1.1 Causes and Contributing Factors

1.2 Preparation and Planning

Bushfire Assessment - OEH submission to DPIE on Wilton South East - 2017

Figure 7.1 - OPAs and IPAs as used in Asset Protection Zones

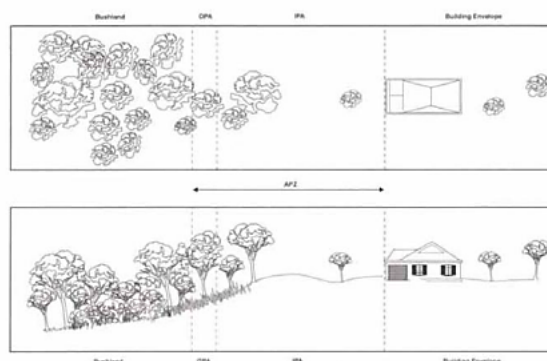
Property length 60m, APZ 32m to 70m

Due to much of the Wilton Junction area being affected by large APZ requirements it is envisioned that some areas of forest beyond the dashed green line on the plan set may be managed as an outer protection area. Table A2.7 in Planning for Bushfire Protection lists the size of allowable OPAs and is reproduced below:

No 21 to No 23 are the areas with the house lots that do not have a perimeter road. The desire to relocate a fire trail to be part of the APZ is in vast contradiction to the guide lines set out in the major report that is listed in the DA as being the guide lines that this project is being built to.

Figure 2.4 –Landowners, InSites 2013

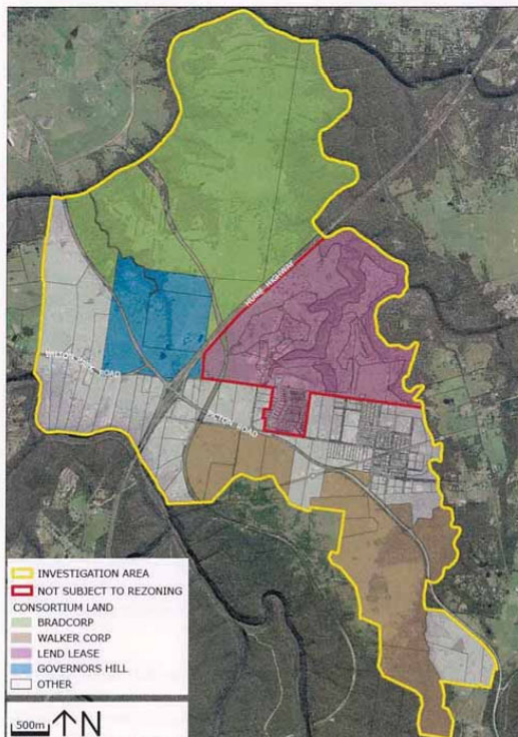
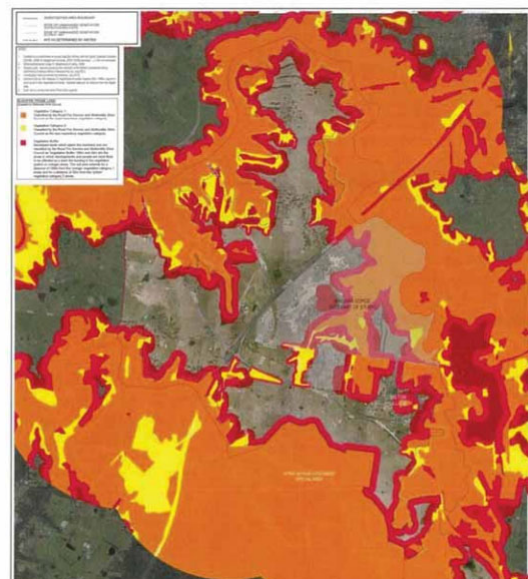
Bushfire danger zones are assessed by consultants for developers, and seem to vanish at the boundary of the proposed urban area, as can be seen below on the south west side where the actual shapes of the bushfire vulnerable area mysteriously takes on the exact shape of the Wilton South East Precinct Boundary:
